Attachment 1  
to NLS2000033

**Review of Sciencetech Calculation 17080-M-01,  
X/Q Values for Control Room Intake  
Using ARCON96  
Attachment 1 to NEDC 99-031, Revision 1  
(91 pages plus 6 page NEDC cover)**

Title: <u>Review of Scientech Calculation 17080-M-01, X/Q Values for Control Room Intake Using ARCON96</u> System/Structure: <u>HVAC, SGT, SC / ERP</u> Component: <u>N/A</u> Classification: [ X ] Essential; [ ] Non-Essential	Calculation No: <u>NEDC 99-031</u> Task Identification No: <u>N/A</u> Design Change No: <u>N/A</u> Discipline: <u>Mechanical Design</u>
---	--

NEDC: 99-031 Preparer: Scientech, Inc. Reviewer: J. J. Drasler  
 Rev. No: 1 Date: 3/20/00 Date: 3/21/00

Figure 1. Schematic layout of release points and control room intake showing design input information.

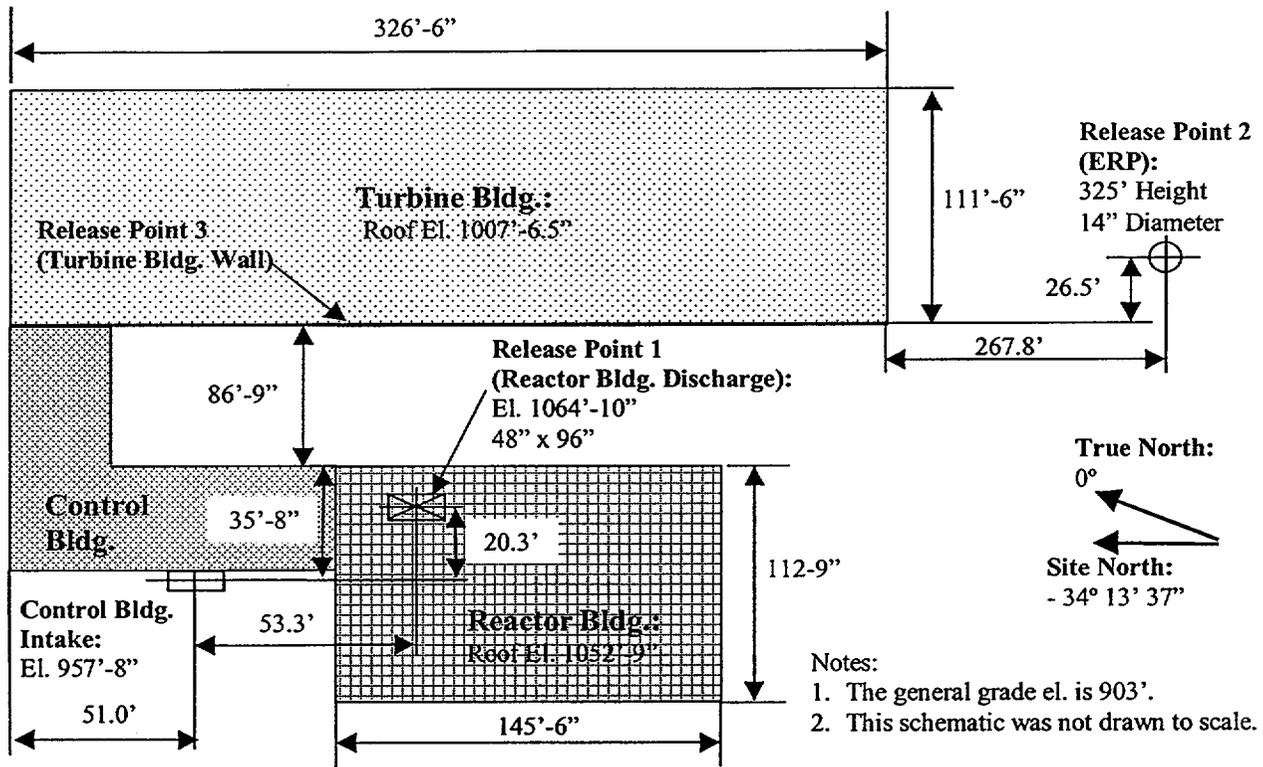
- 4.2 Figure 1 shows the following for the reasons given (CNS, Burns & Roe Drawings: 2209 Rev. 3, 2217 Rev. N08, 2194 Rev. N03, 4005 Rev. N01, 2037 Rev. N54, and 4506 Rev. N06): [5.10]

- Dimensions for calculating the orientation (angle) and the distance between release points and the control room intake.
  - Elevations of release points and general grade elevation to calculate height of release points.

- Elevation of the control room intake to calculate its height above grade elevation
  - Turbine and reactor building dimensions and roof elevations to calculate the cross-sectional areas of the buildings in order to model building wake effects.

- Height of the elevated release point.
  - Cross-sectional dimensions of reactor building and ERP vents to calculate cross-sectional areas, which are used to calculate, release velocities.

- Difference between the true north and the site north directions to calculate orientation angles between release points and the control room intake with respect to the true north direction.
